LIMITING CONDITIONS FOR OPERATION

3.6 Primary System Boundary

APPENDIX B

Figure 3.6.1.a Minimum Temperature for Non-Nuclear Heatup/Cooldown

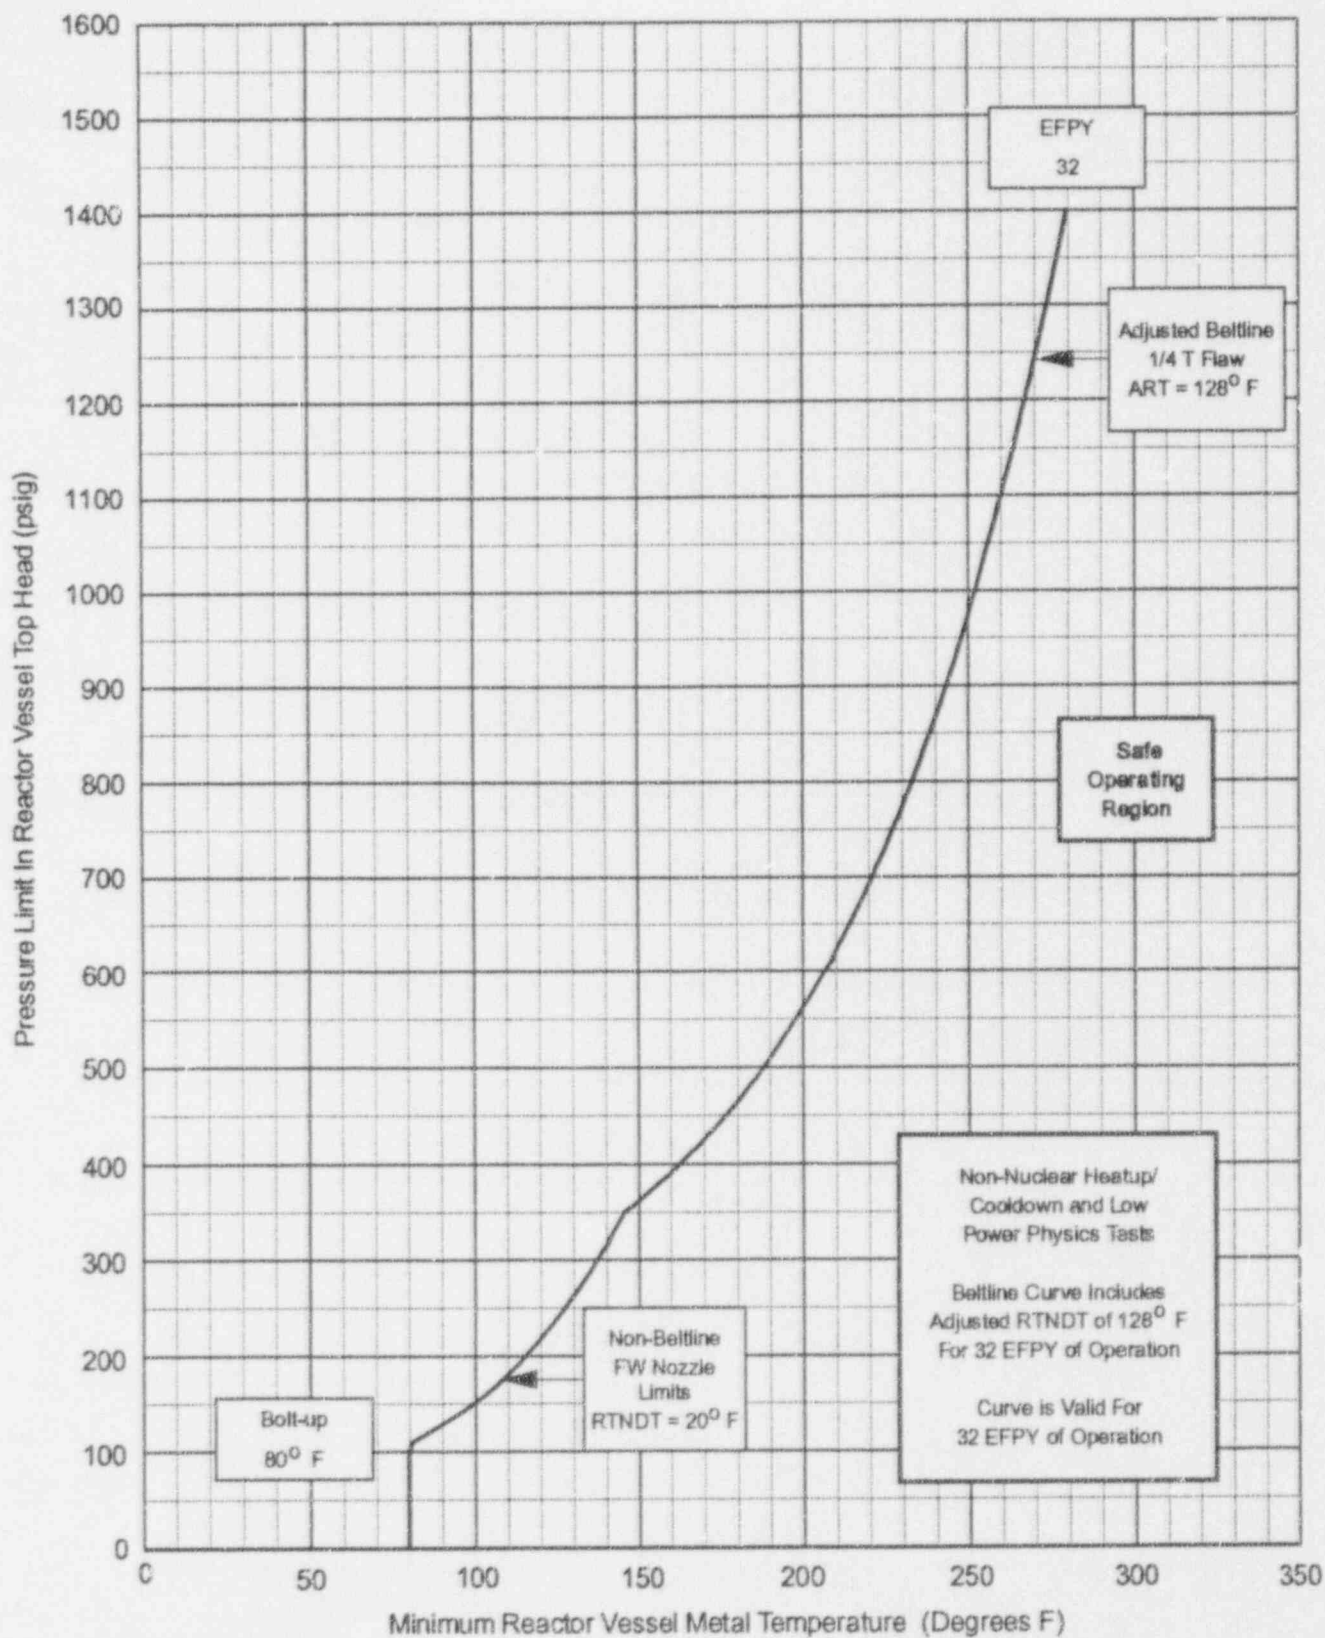
2. ~~or~~ During operation where the core is critical, ~~or~~ during heatup by nonnuclear means or cooldown following shutdown, ~~the~~ reactor vessel metal and fluid temperatures shall be at or above the temperatures shown on the limiting curves of Figures 3.6.1.a or 3.6.1.b. This specification applies when the reactor vessel head is tensioned.

Figures 3.6.1.a, 3.6.1.b, and 3.6.2 reflect the results of this testing and analysis, which includes consideration of the test results obtained from the specimens removed with the first surveillance capsule. Figures 3.6.1.a and 3.6.1.b have been calculated through end-of-life, and reflect a calculated Adjusted Reference Temperature (ART) of 128°F at 32 EFPY. Figure 3.6.2 includes curves corresponding to 15, 18, 21, 24, and 32 EFPY which correspond with ARTs of 89, 96, 101, 108, and 128°F respectively, in order to provide greater flexibility during pressure testing. ← same 91 →

2. During heatup by nonnuclear means or cooldown following shutdown, or during operation where the core is critical, the reactor vessel metal and fluid temperatures shall be at or above the temperatures shown on the limiting curves of Figures 3.6.1.a or 3.6.1.b as applicable. This specification applies when the reactor vessel head is tensioned. This specification does not apply to heatup or cooldown for the purpose of performing inservice hydrostatic or leak testing.

Figures 3.6.1.a, 3.6.1.b, and 3.6.2 reflect the results of this testing and analysis, which includes consideration of the test results obtained from the specimens removed with the first surveillance capsule. Figures 3.6.1.a and 3.6.1.b have been calculated through end-of-life, and reflect a calculated Adjusted Reference Temperature (ART) of 128°F at 32 EFPY. Figure 3.6.2 includes curves corresponding to 15, 18, 21, 24, and 32 EFPY which correspond with ARTs of 89, 96, 101, 108, and 128°F respectively, in order to provide greater flexibility during pressure testing. Figure 3.6.2 also has a separate curve for the bottom head region. The bottom head curve does not shift with increased operation; therefore, the bottom head temperature can be monitored against lower temperature requirements than the beltline during pressure testing. The surveillance capsule withdrawal schedule for the remaining specimens is located in Section IV.2.7 of the CNS USAR.

Figure 3.6.2 Minimum Temperature for Pressure Tests

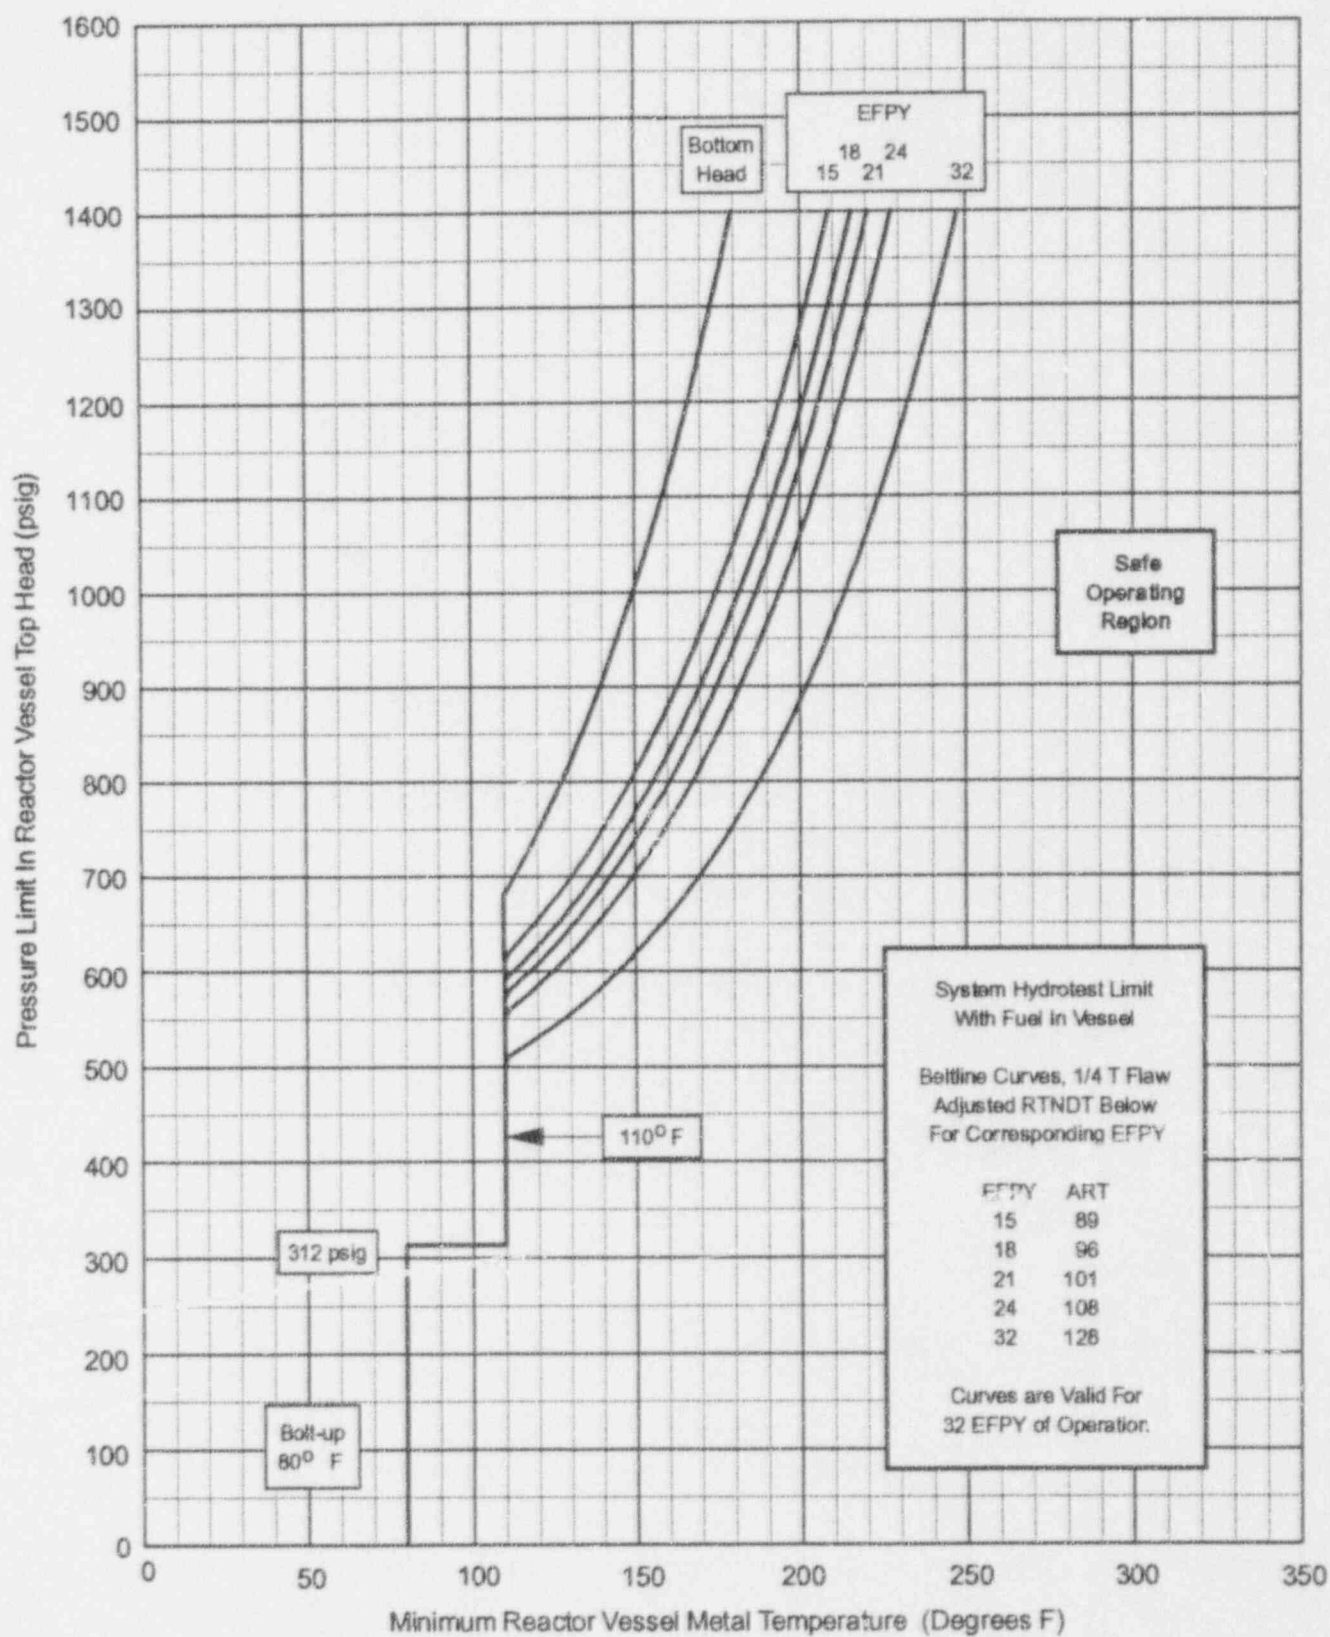
3. The reactor vessel metal temperatures for the bottom head region and beltline region shall be at or above the temperatures shown on the limiting curves of Figure 3.6.2 during inservice hydrostatic or leak testing. The Adjusted Reference Temperature (ART) for the beltline region must be determined from the appropriate beltline curve (13, 18, or 21, EFY) depending on the current accumulated number of effective full power years (EFY).

15, 18, 21, 24, or 32

3. The reactor vessel metal temperatures for the bottom head region and beltline region shall be at or above the temperatures shown on the limiting curves of Figure 3.6.2 during inservice hydrostatic or leak testing. The Adjusted Reference Temperature (ART) for the beltline region must be determined from the appropriate beltline curve (15, 18, 21, 24, or 32 EFPY) depending on the current accumulated number of effective full power years (EFPY).
